ADDENDUM NO: 03

DATE: 08 April 2025

PROJECT NO: 119.002

PROJECT: Hyde Park Elementary School
333 East 300 North
Hyde Park, Utah 84318

A2 / A107b AREA C2 REFERENCE FLOOR PLAN
1/8" = 1'-0"

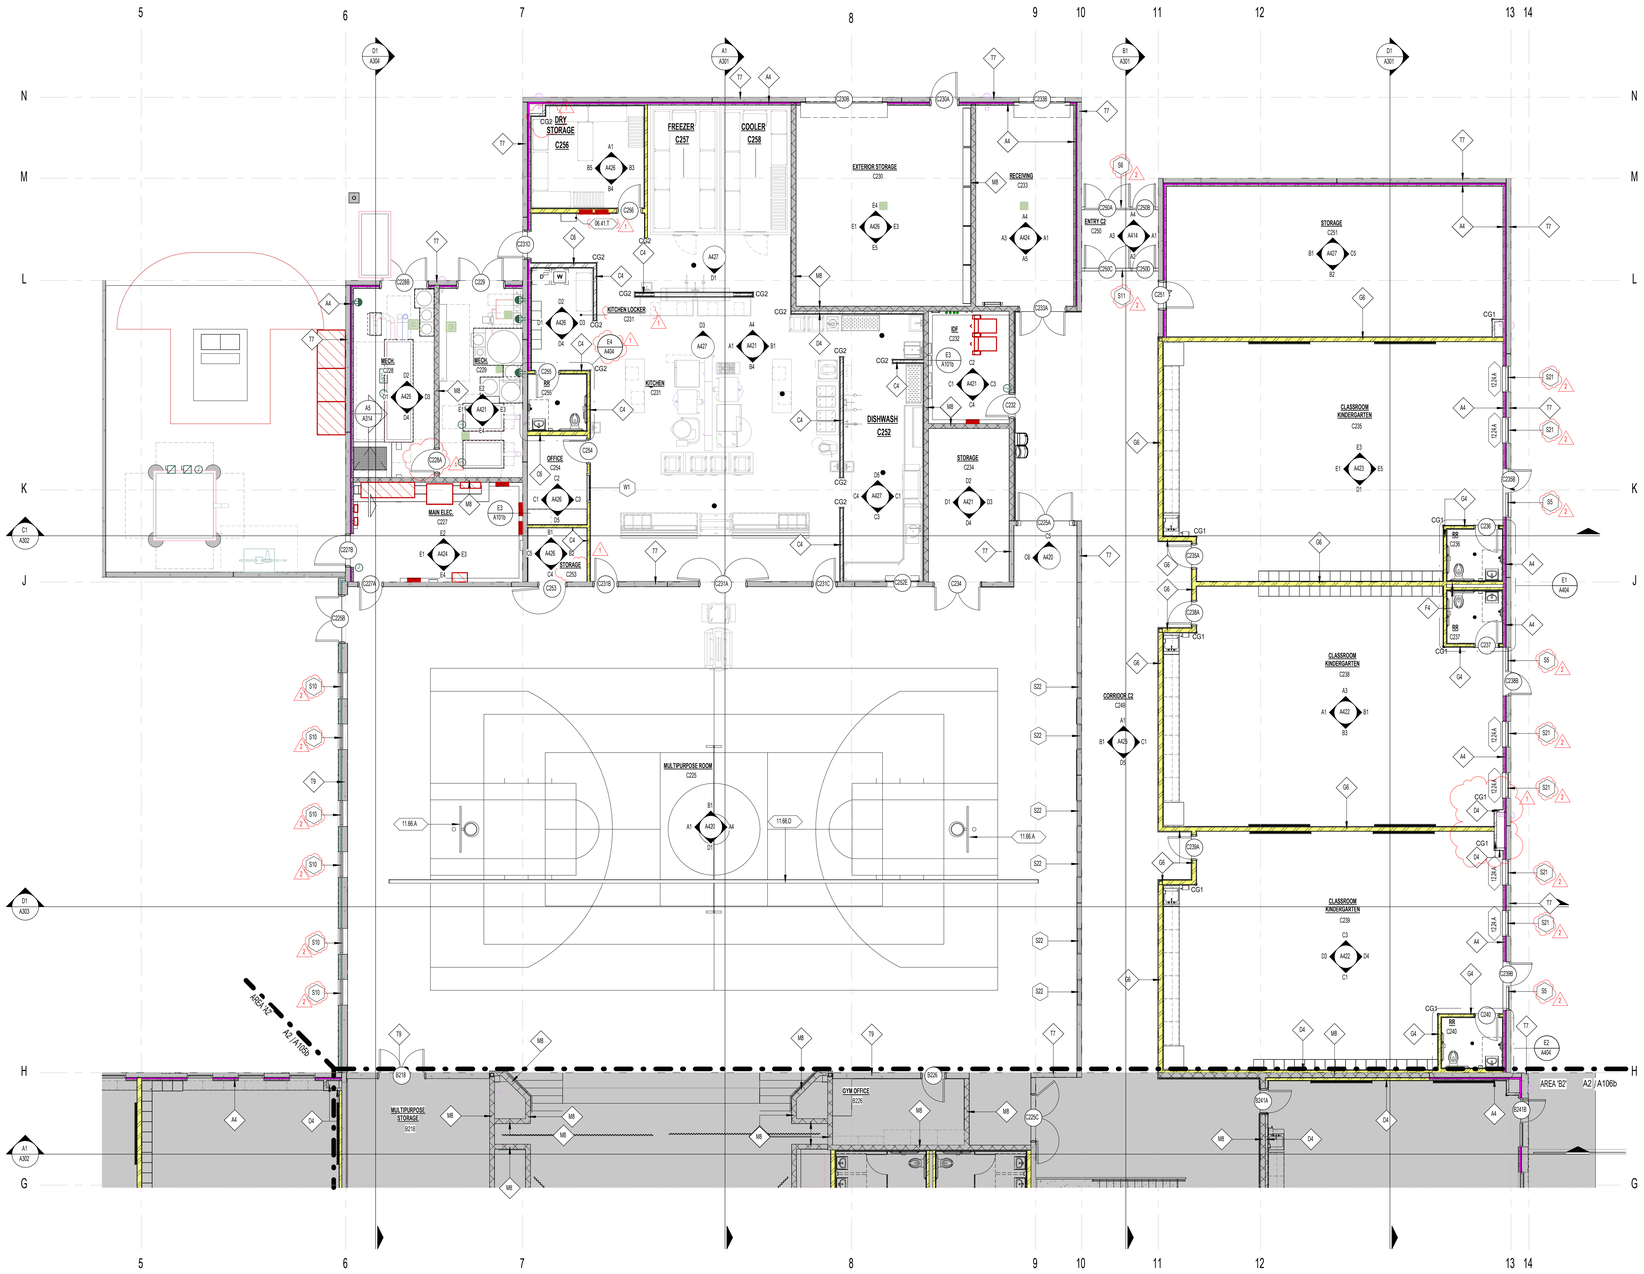
- **Window tags added to all windows on plan**

1 ROOF PLAN
A171 1" = 10'-0"

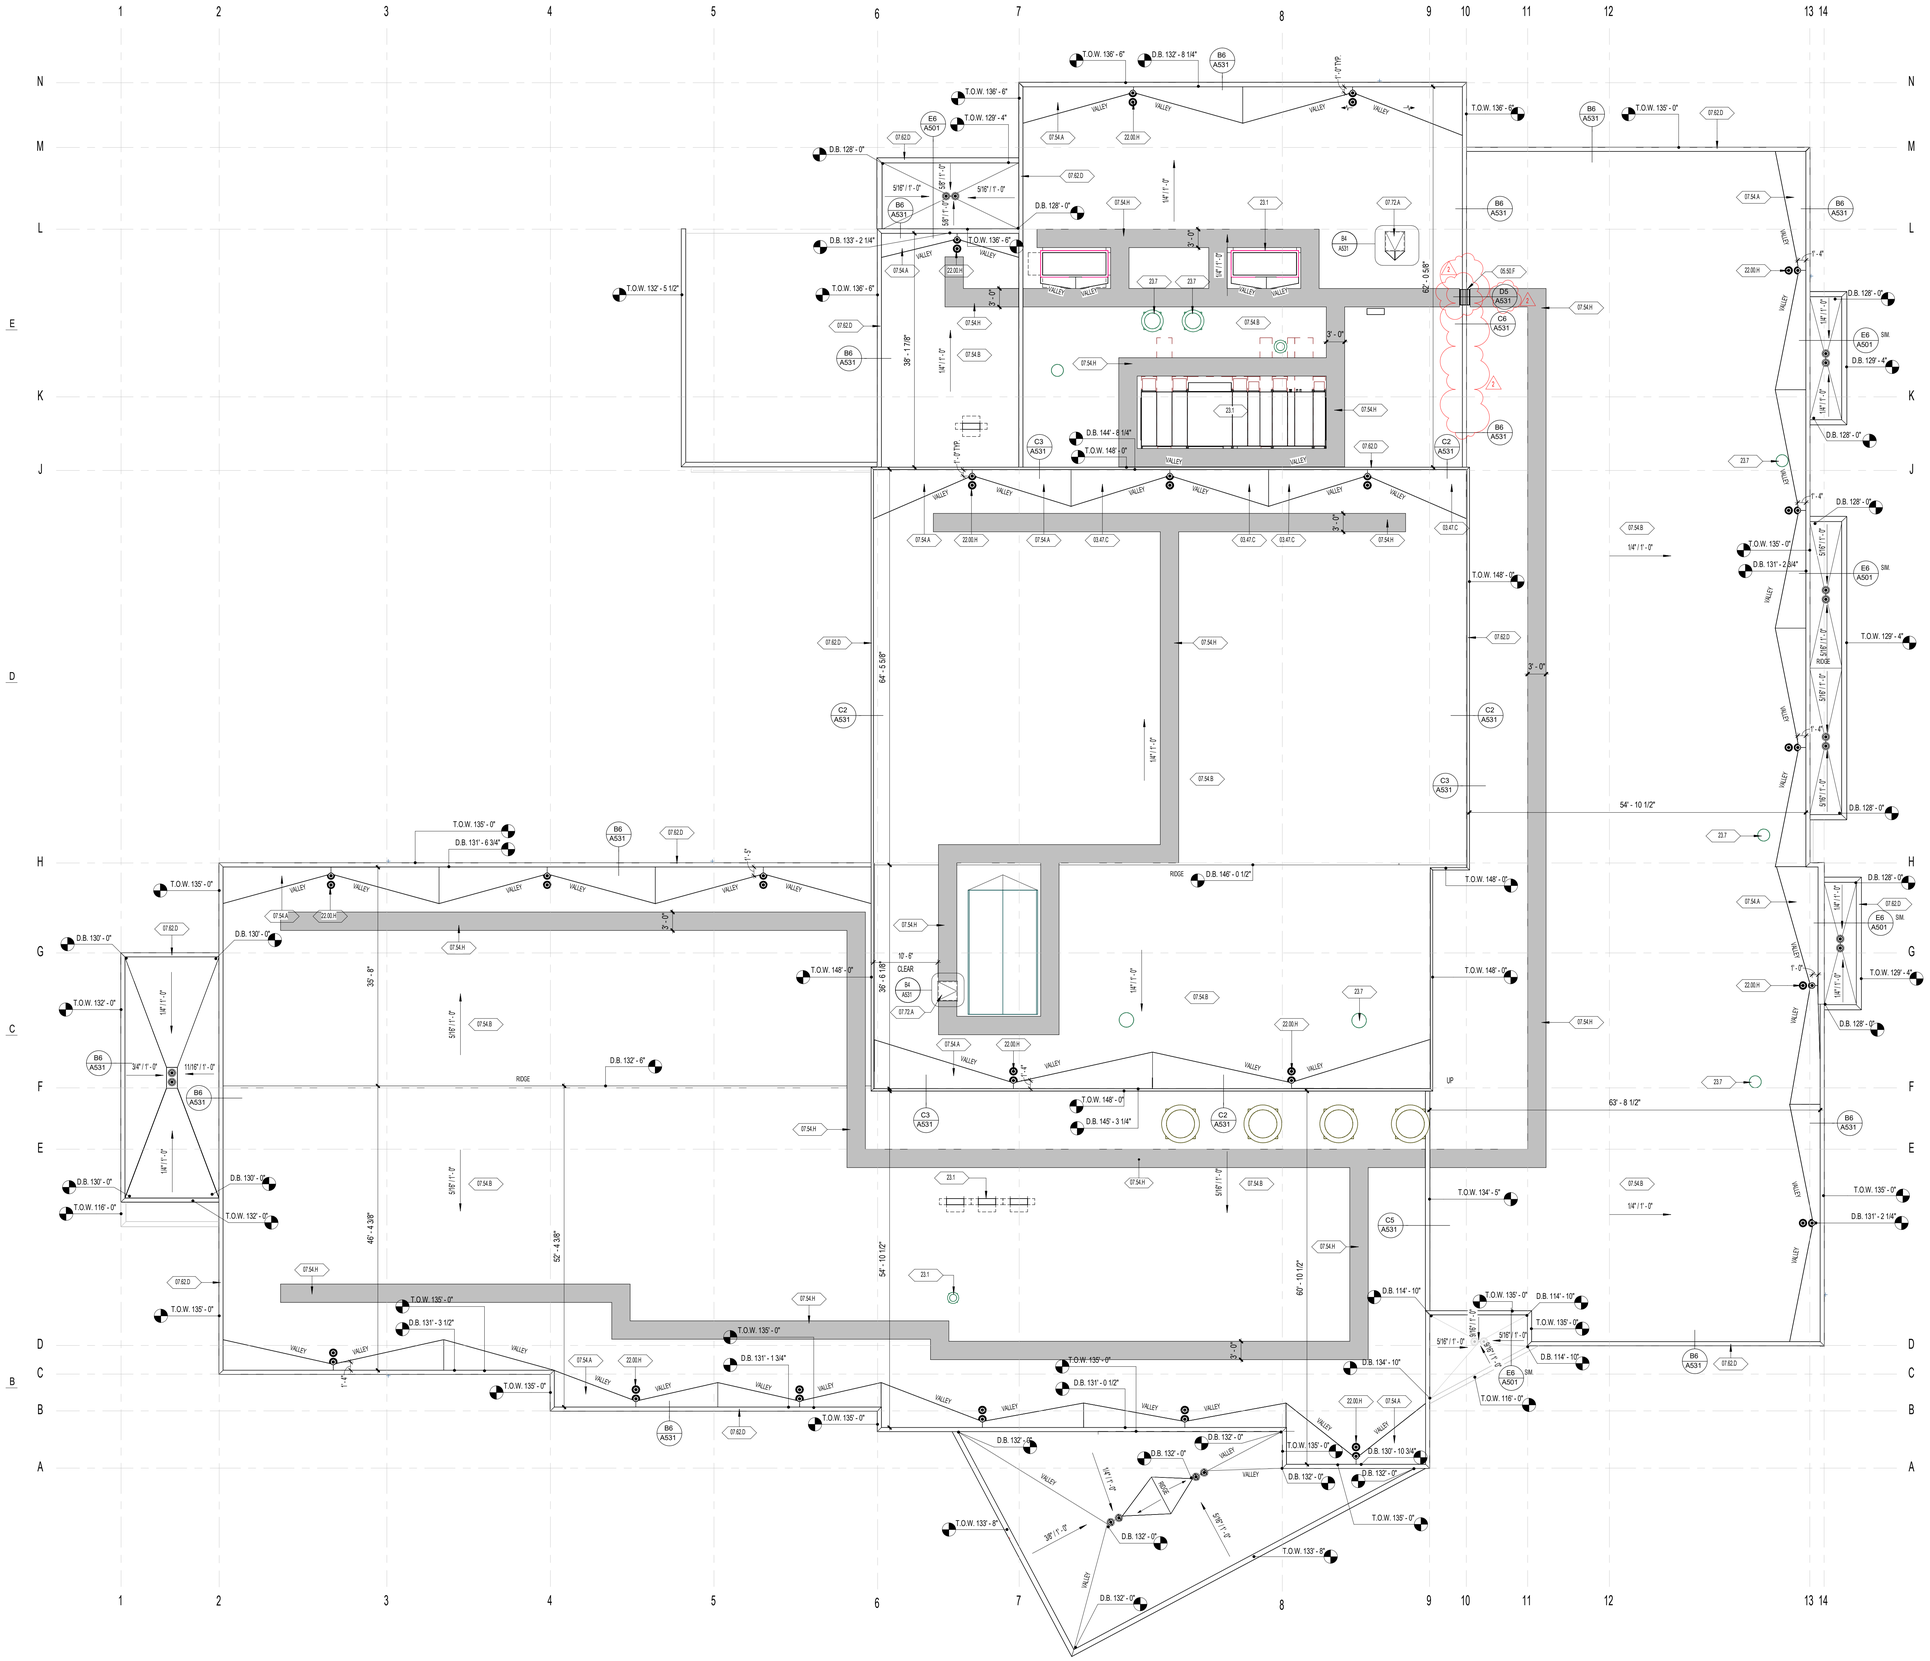
- **Adjusted detail C6/ A531 to have corrected stud size.**
- **Added detail D5/ A531 to show roof access ladder detailing.**
- **Added roof access ladder.**

1 LEVEL 01 TILT UP CONCRETE PANELS
A901 1" = 10'-0"

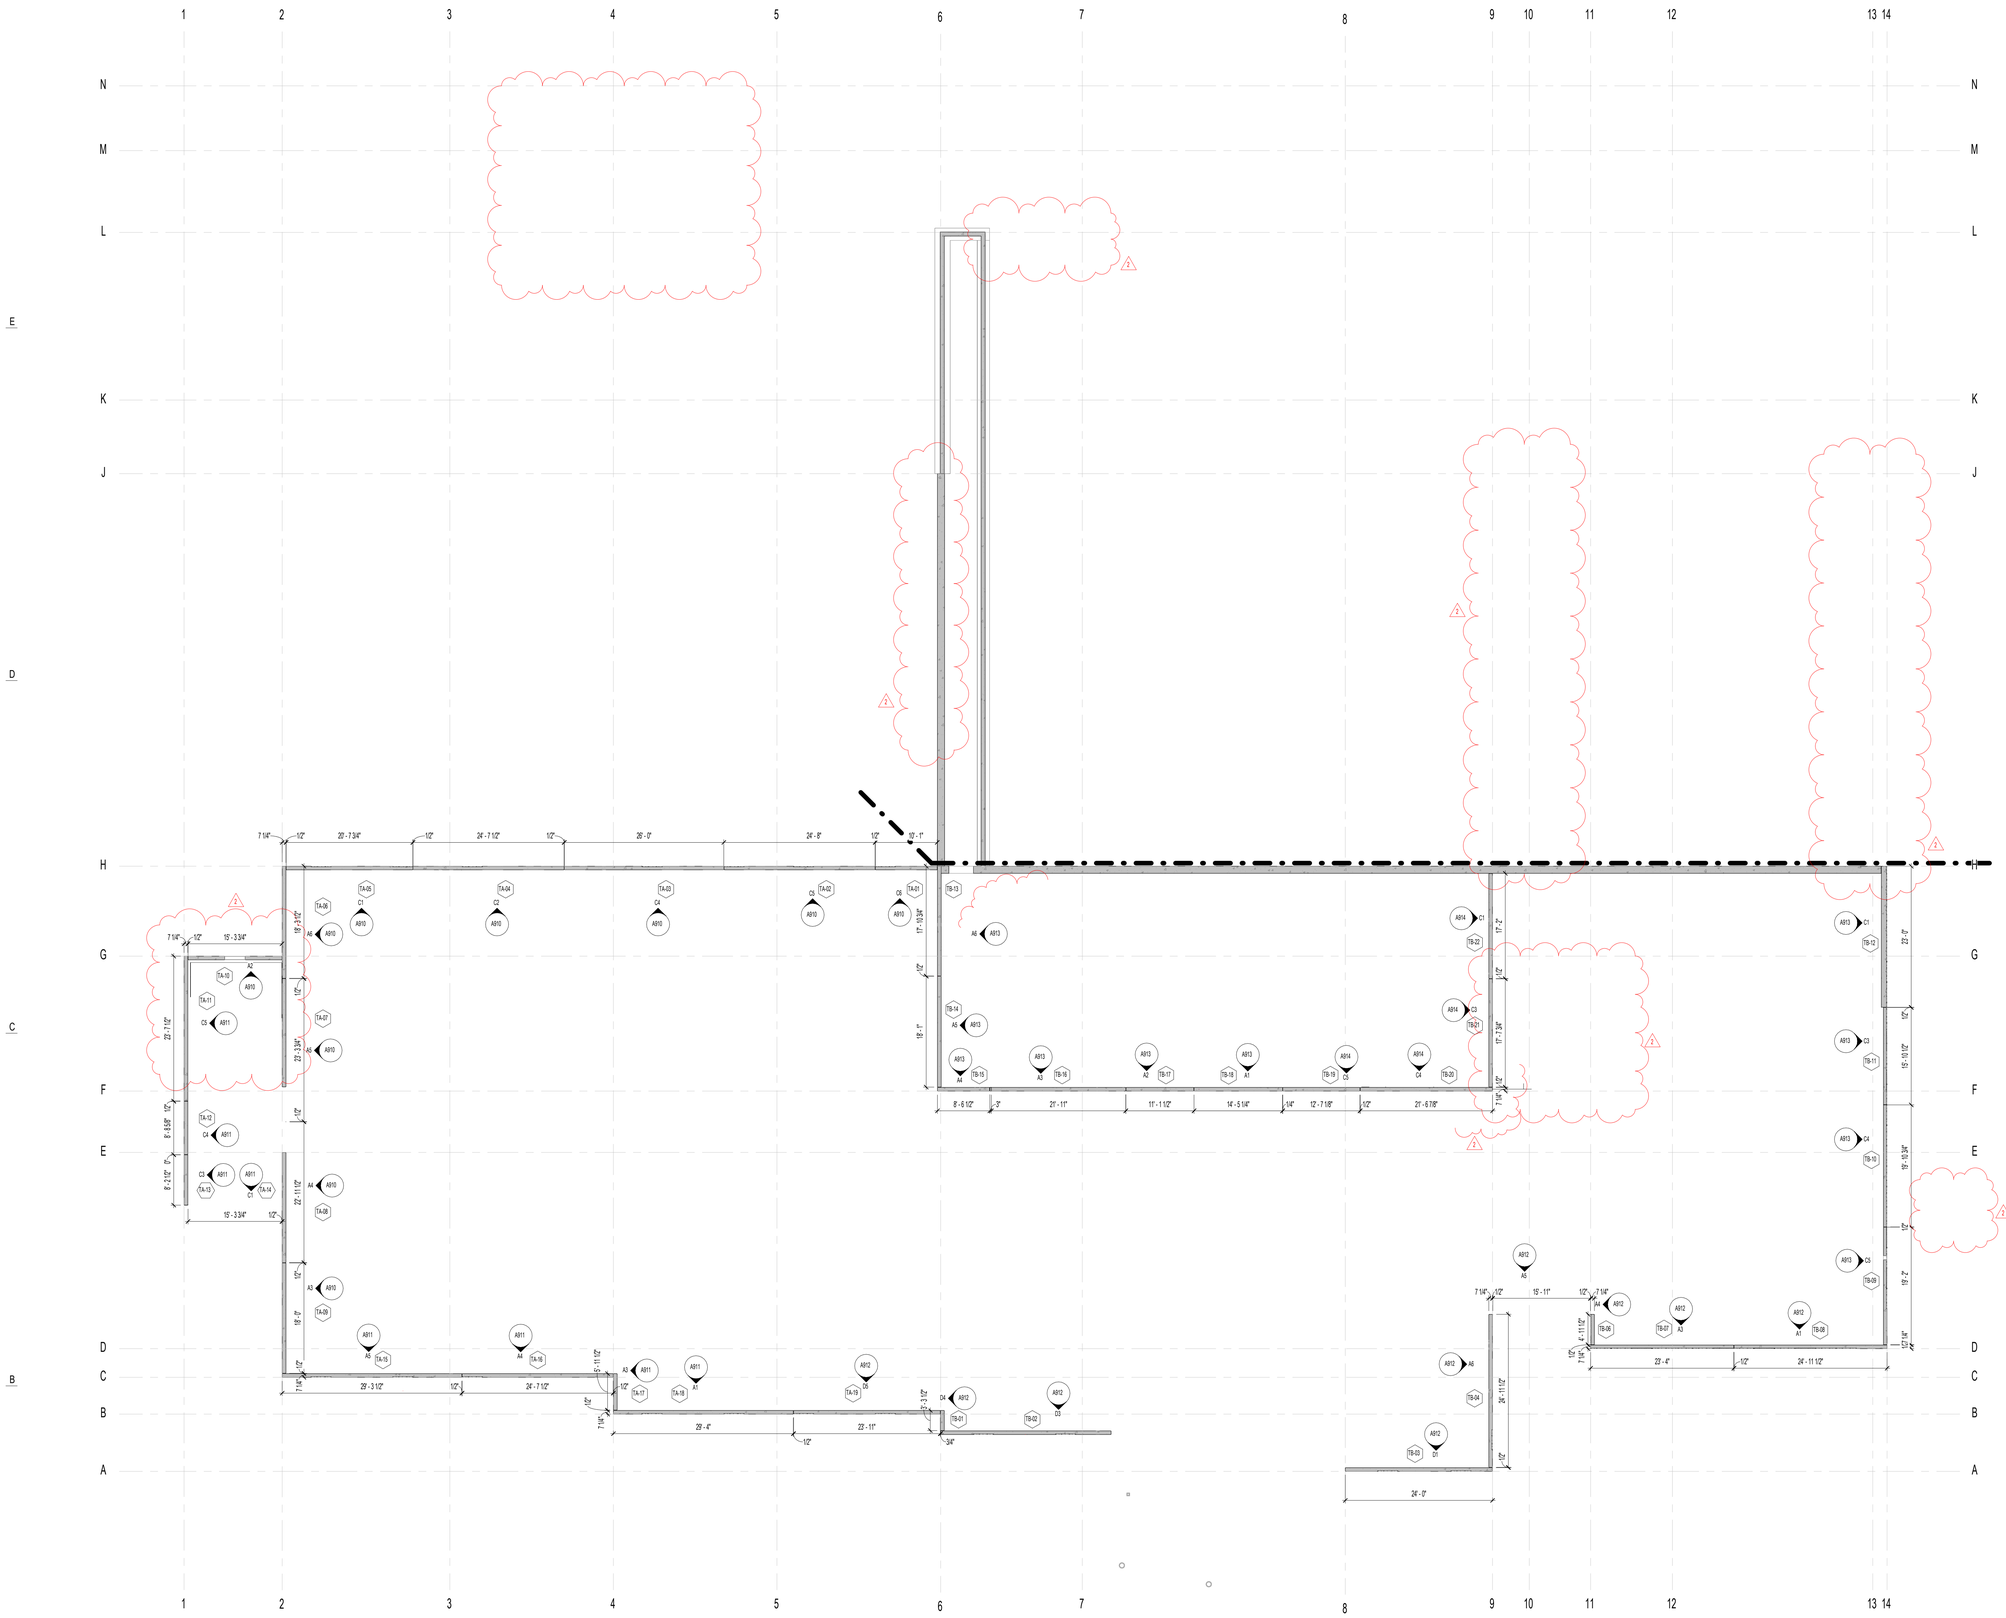
- **All stairs, mechanical equipment, and footings were removed from view to provide better clarity on plan.**
- **Trash enclosure walls and elevations were moved to A901 – OVERALL LEVEL 01 TILT PANEL PLAN**
- **Detail A1/ A918 call out removed from sheet**
